TOWN OF AJAX
65 Harwood Avenue South
Ajax ON L1S 2H9
www.ajax.ca

May 5, 2015

Memo To: Paul Allore
Memo From: Martin T. Auer
Date April 30, 2015
Subject: York Region Technical Memorandum – Actiflo – March 11, 2015
cc: Jennifer Danahy

This memo constitutes a review of the Technical Memorandum entitled, “Conceptual Design of Actiflo Process for Tertiary Treatment at the Duffin Creek Water Pollution Control Plant (Duffin Creek WPCP). The memorandum consists of a *Conceptual Design of Actiflo® Process* (hereafter, *Conceptual Design*) for implementation of the technology prepared by CH2M Hill for the Regions of York and Durham, accompanied by a *Letter of Transmittal* co-authored by the Regions’ Project Managers.

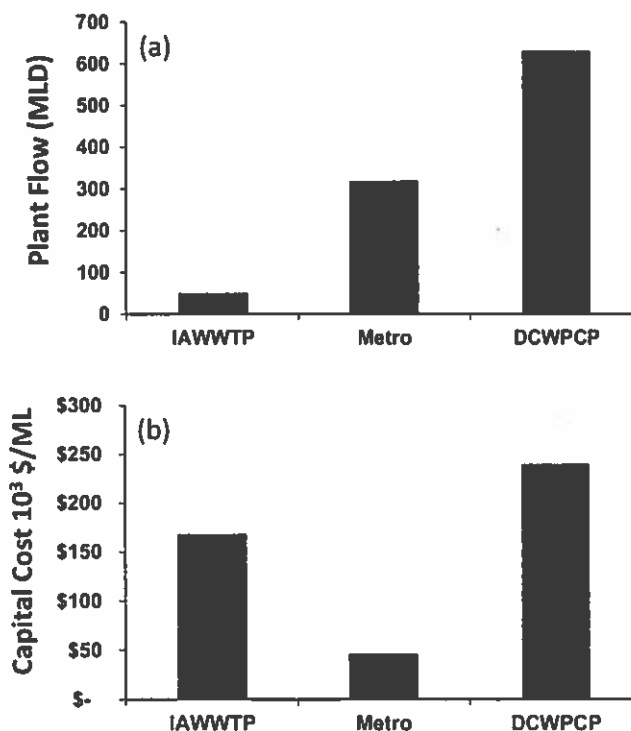
- a) *Capital cost comparisons* – the *Conceptual Design* used in deriving a cost estimate of \$151 million for implementation of ballasted flocculation is based on application of the technology at Metro, yet no side-by-side cost comparison to that facility or others using the technology is presented. Lambert et al. (In Review) report that capital costs at Metro were \$14.8 million (2015 dollars) to treat 319 MLD and \$8.4 million (2015 dollars) at IAWWTP to treat 50 MLD (M.T. Auer, unpublished). *It is recommended that the capital costs estimated for implementation at the Duffin Creek WPCP be compared with the actual capital costs incurred at Metro and the IAWWTP, appropriately scaled to plant size and infrastructure requirements (Figure 4).*
